IN THE DRAWINGS:

**REMARKS:**

This application has been carefully studied and amended in view of the Office Action dated September 26, 2005.

Fig. 17.

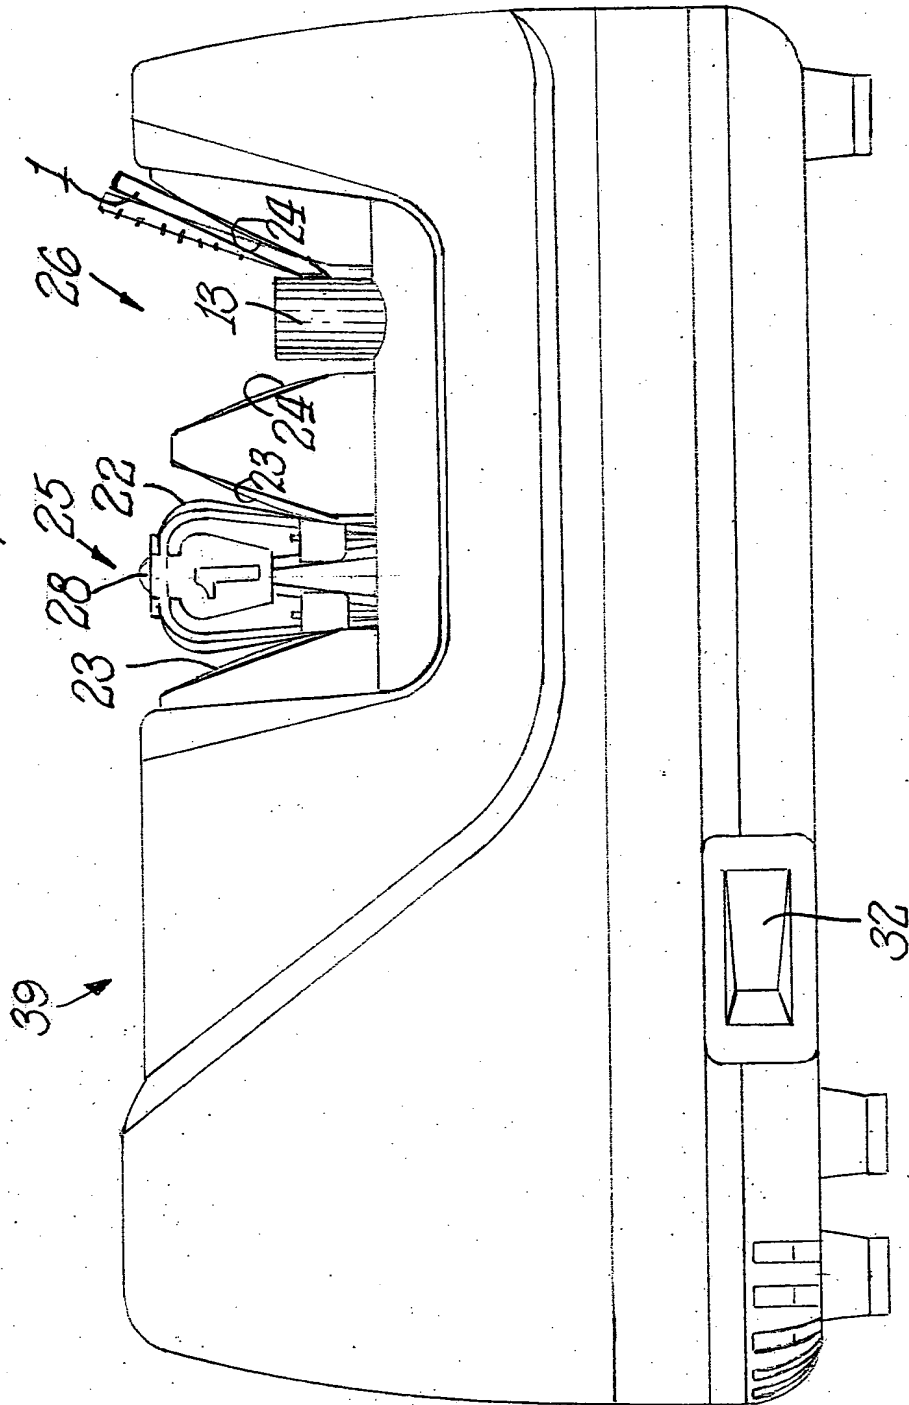
Amend Figures 17, 18, 19 and 20 as indicated in the annotated sheets of those drawings which have been marked in red to show the changes. Also attached are replacement sheets.

In reviewing the application it was realized that Figures 17-20 were slightly inaccurate in that the guide surfaces 23 and 24 of Figures 17-18 and the guide surfaces 23, 24 and 21 of Figures 19-20 were slightly curved rather than being planar as clearly described in the specification. Accordingly, those figures have been amended for consistency with the specification. In that regard, with respect to Figures 17-18 page 29, lines 2-12 specifically refers to the surfaces 23 and 24 as being guide "planes". See also paragraph 50 of the published form of this application, U.S. 2004/0198198. As regards Figures 19-20 those figures show a three stage apparatus and the specification clearly refers to each stage as including a guide "plane". See, for example, page 33, lines 3-5 and 29-30 and page 34, lines 1-10 of this application and their corresponding portions in paragraph numbers 55, 57 and 58 of the published application. Note is also made to Figures 11, 14, 16 and 16a which clearly illustrate planar guide surfaces.
